T.I. No.: 2021-10 Updated: -	Topic: Replacing the control panel (touch screen)
---	--

Replacing the control panel (touch screen)

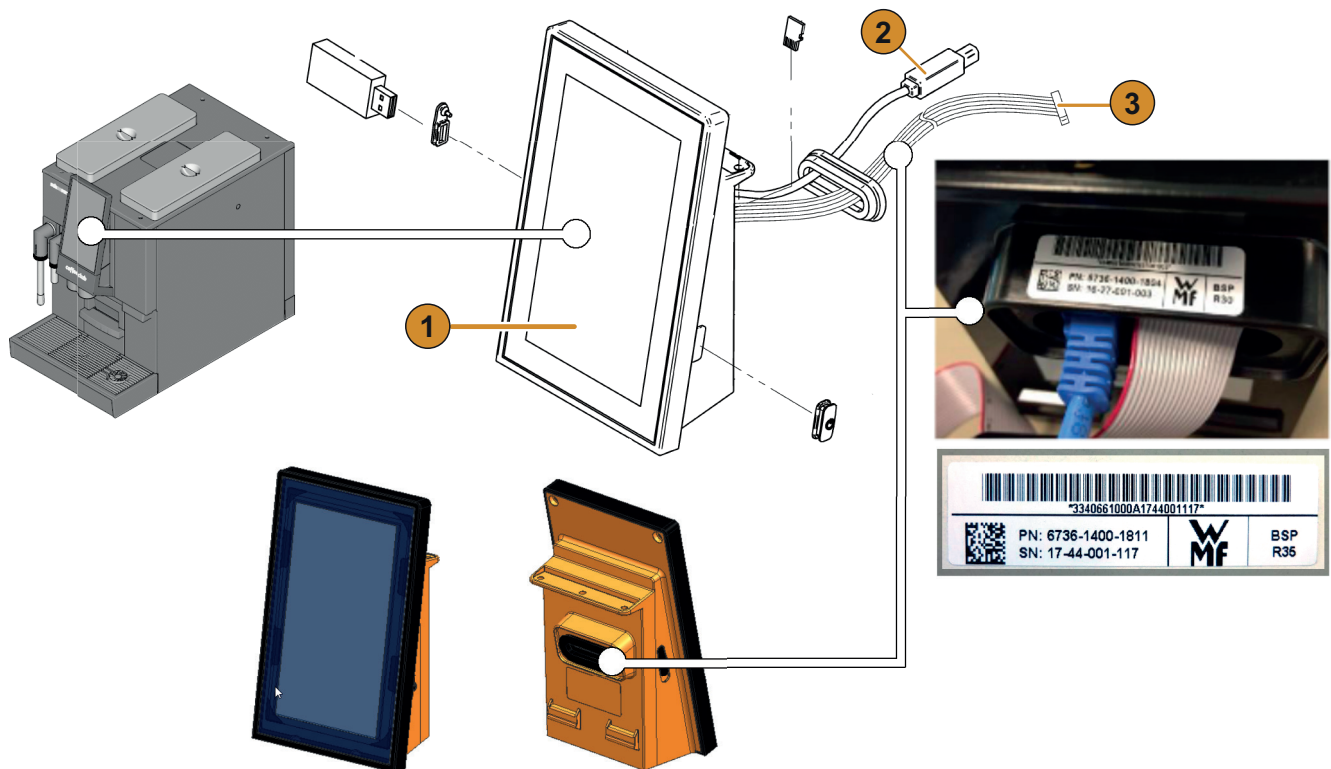
The SC Club control panel is supplied fully wired, consisting of control panel (1), USB cable (2) and ribbon cable (3).

In case of a warranty claim, the control panel including the cables must be returned to Schaeerer AG. The warranty will expire if the cables have been dismantled and are missing.

Position	Naming	Article number
1	Control panel SC Club (Touch screen)	33.4066.1000 33.4066.1299 (Successor model)
2	USB cable	33.4167.0000
3	Ribbon cable	33.4156.9000
